Charlotte Historic District Commission Staff Review HDC 2016-103 Application for a Certificate of Appropriateness

PROPERTY ADDRESS: 2219 The Plaza

SUMMARY OF REQUEST: Addition

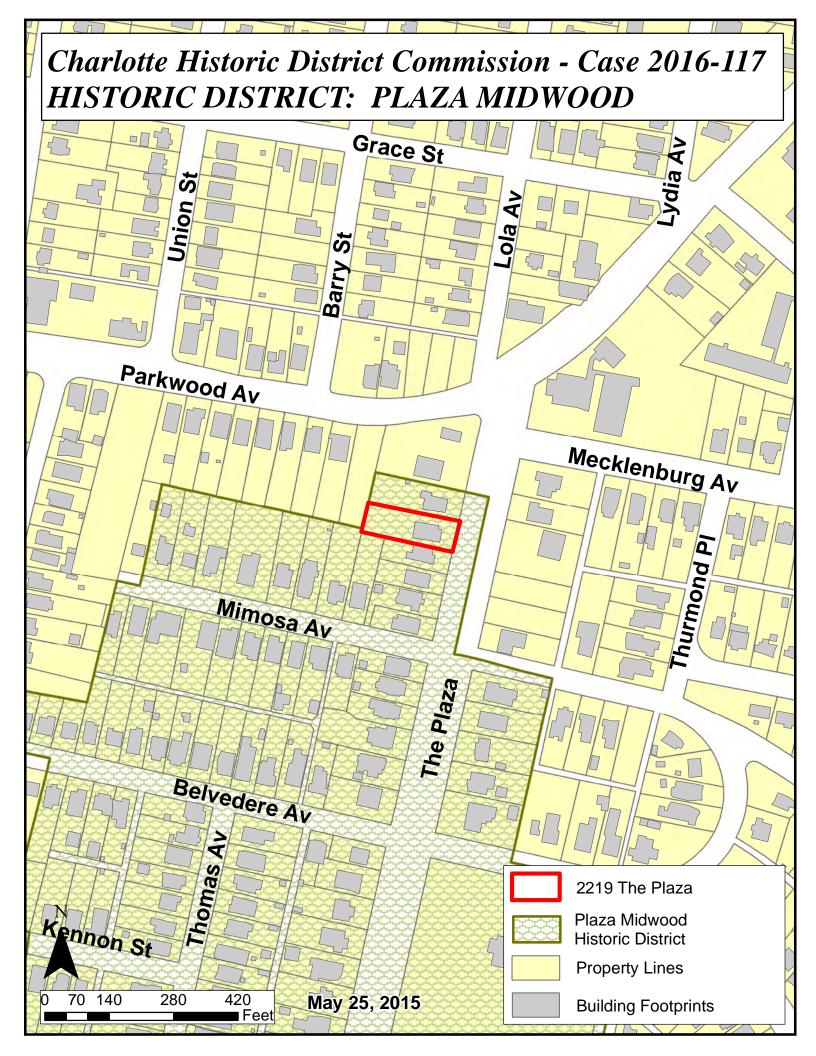
The application was continued for additional details on materials and massing of the addition. Reduce the massing of the second floor by bringing the walls in and not repeating the stucco and board and batten on the walls but only in the gable, or other traditional materials could be proposed in repairing the shape of the gable on back door to match the rest of the house.

- The roof has been changed to a gable at the rear of the addition.
- The side gable on the right side elevation has been moved toward the front.
- The rear porch roof has been reduced.
